ITEM #2: AREA-WIDE PARK FACILITIES

Plan Vision and Challenges

Park, Trails and Open Space Concept

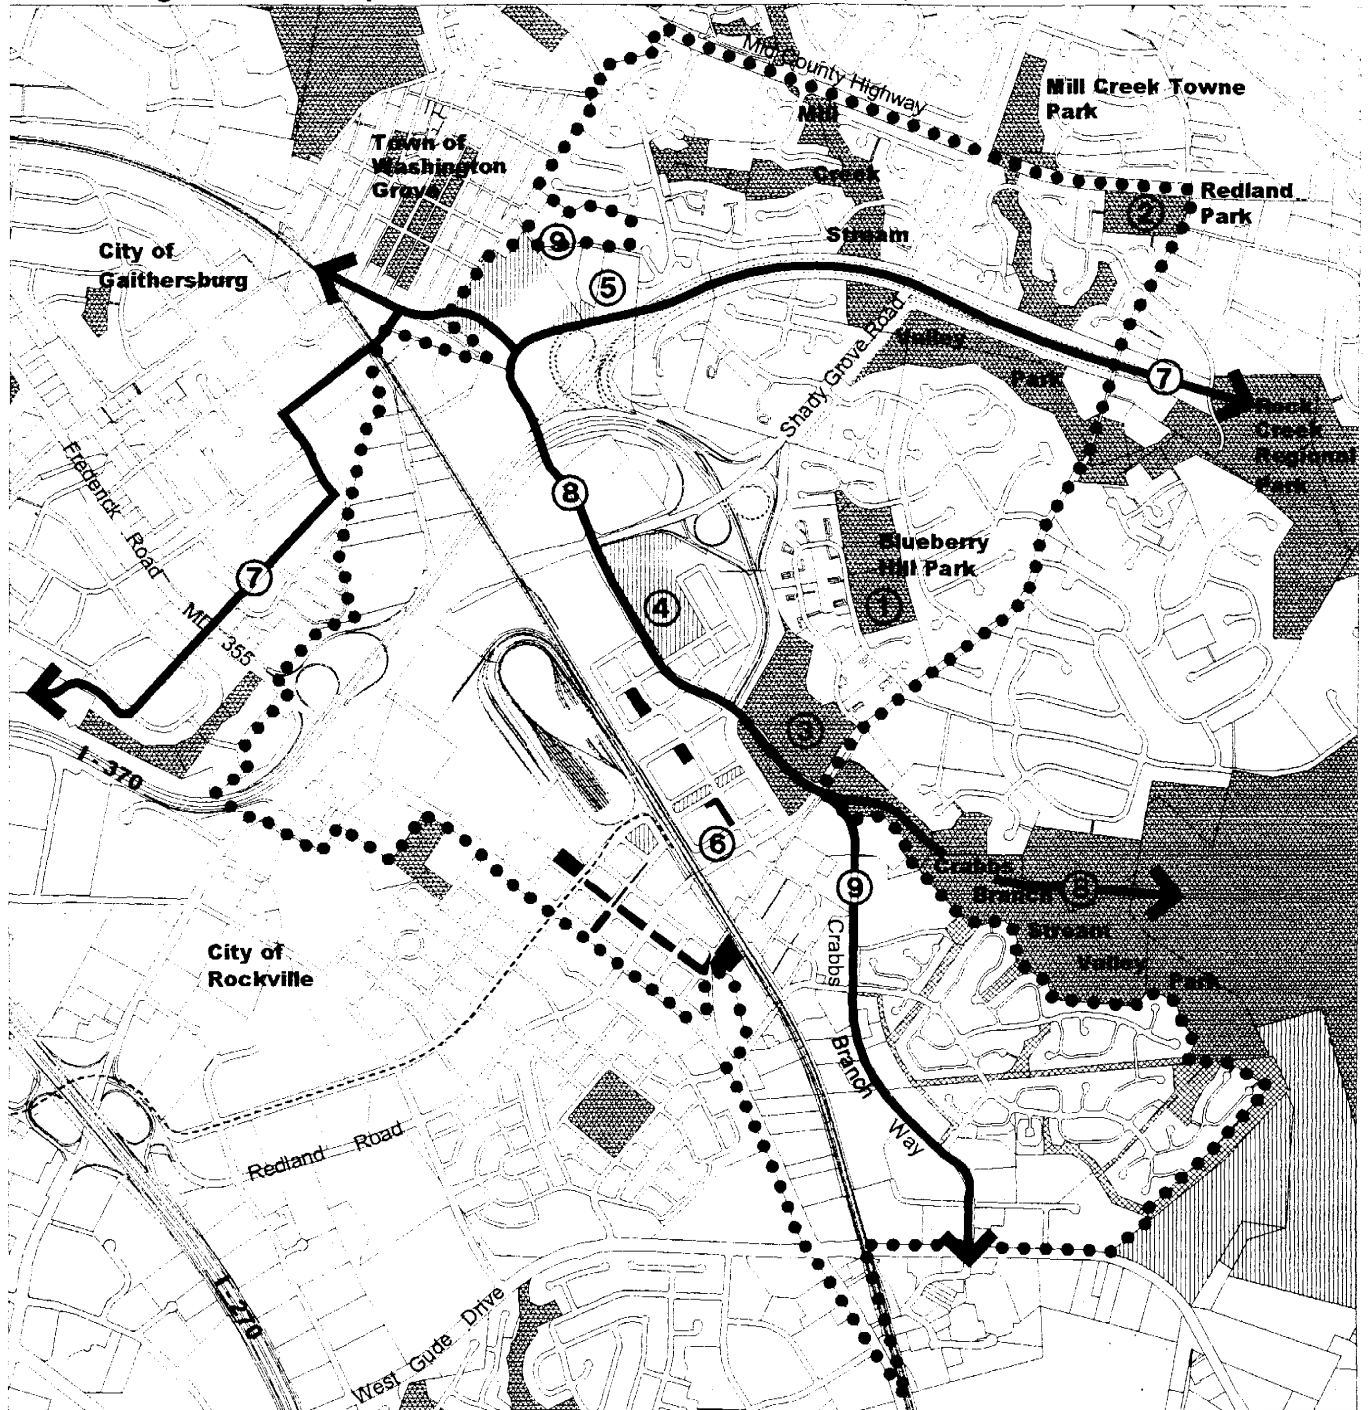
Residents support the Plan's proposed new parks, citing the need to serve existing and new residents. The County Executive Staff questions the need for Jeremiah Park.

An analysis of future *PROS* needs for Shady Grove shows that the addition of 5,400 dwelling units, a population increase from 7,236 to more than 17,000 people, would generate an estimated need for three additional fields, one multi-use/basketball court and nearly three playgrounds.

These needs are met by the Plan's recommendations for two fields, a playground, and a multi-use court at Jeremiah Park; one field and a playground at the elementary school; and one playground on the new neighborhood park on the Casey at Mill Creek property. The undeveloped portion of Blueberry Hill Local Park may also be needed to provide long-term active recreation needs.
